**STATE OF DELAWARE
EXECUTIVE DEPARTMENT
OFFICE OF STATE PLANNING COORDINATION**

December 23, 2015

RE: PLUS review 2015-11-11; Cape Henlopen School District – Sussex Consortium 3

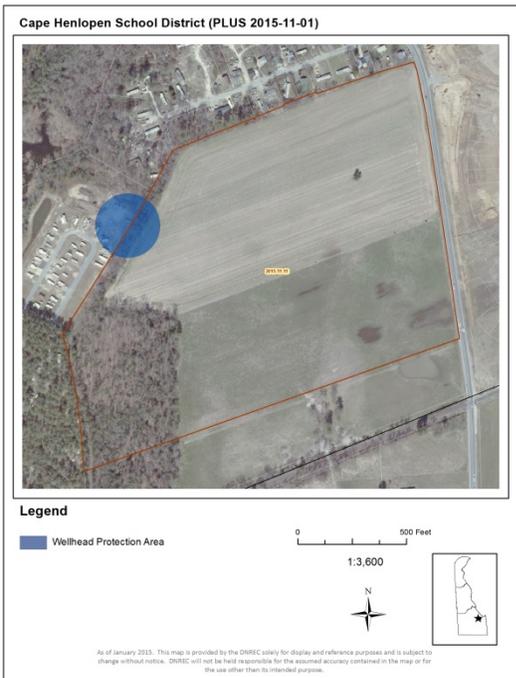
- DNREC has determined that the project falls within a wellhead protection area and an excellent groundwater recharge potential area for Sussex County (see map). The wellhead protection area is associated with a public well at Tall Pines Campgrounds. Sussex County's Source Water Protection Ordinance meets only the minimum standards of protection. DNREC has in the past, and continues to encourage the County to revise their ordinance to strengthen the level of protection.

well where land use activities or impervious cover may adversely affect the quantity and quality of ground water moving toward such wells. Development within the wellhead protection area should be avoided.

In addition, because the wellhead protection area is an existing source of public drinking water and the excellent groundwater recharge area so readily affects the underlying aquifer, the storage of hazardous substances or wastes should not be allowed within these areas unless specific approval is obtained from the relevant state, federal, or local program.
